Access Compliance Report

Public Rights-of-Way

(Curb Ramps)

Intersection ID: 3497	Main Street: SAWGRASS RIDGE PL	Cross Street: TRADITION VIEW DR	Location: SW
ADA ID: 4FF494D4D1ED	Ramp Type: Perp	Initial Pass/Fail: Fail	Overall Compliance: No
Severity Score: 10			
Codes/Mitigation Info/Possible Solution		Field Measurements/Component Compliance

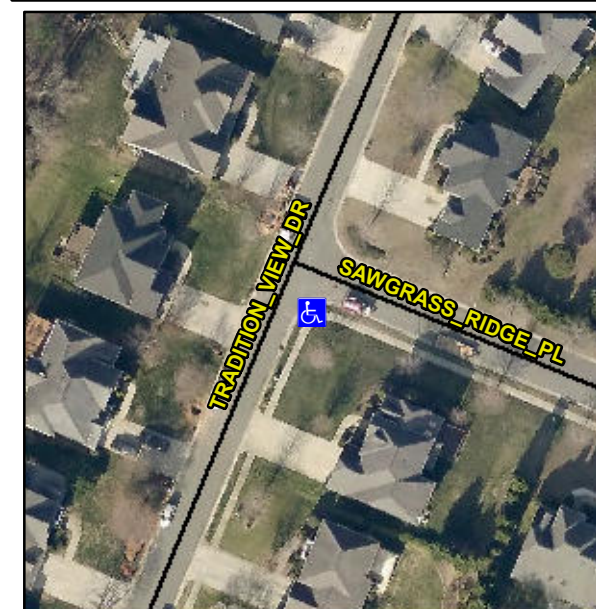
R304.5.1, R304.5.3

Compliance	Description	Data	Compliance	Description	Data
N/A	Ramp Length (in)	51.0	Yes	Ramp Slope (%)	5.0
No	Ramp Width (in)	43.0	No	Ramp XSlope (%)	2.4
N/A	Flare Type LT	N/A	N/A	Flare Type RT	N/A
N/A	Flare Slope LT (%)	N/A	N/A	Flare Slope RT (%)	N/A
N/A	Flare Traversable LT?	N/A	N/A	Flare Traversable RT?	N/A
N/A	Landing Length (in)	N/A	N/A	DWS Provided?	N/A
N/A	Landing Width (in)	N/A	N/A	DWS Contrast?	N/A
N/A	Landing Slope (%)	N/A	N/A	DWS Length (in)	N/A
N/A	Landing X Slope (%)	N/A	N/A	DWS Full Width?	N/A
N/A	Landing Curb? (Y/N)	N/A	N/A	DWS Offset (in)	N/A
N/A	Shared Landing?	N/A			
N/A	Gutter Ponding?	N/A	N/A	Gutter Slope (%)	N/A
N/A	Gutter Lip Ht (in)	1.0	N/A	Gutter X Slope (%)	N/A
N/A	Painted X Walk1?	No	N/A	Painted X Walk2?	N/A
	X Walk 1 Direction	To NE		X Walk 2 Direction	N/A
N/A	X Walk 1 Width (in)	N/A	N/A	X Walk 2 Width (in)	N/A
	X Walk 1 Slope (%)	N/A		X Walk 2 Slope (%)	N/A
	X Walk 1 X Slope (%)	N/A		X Walk 2 X Slope (%)	N/A

Possible Solutions:

Remove & Replace Entire Ramp.
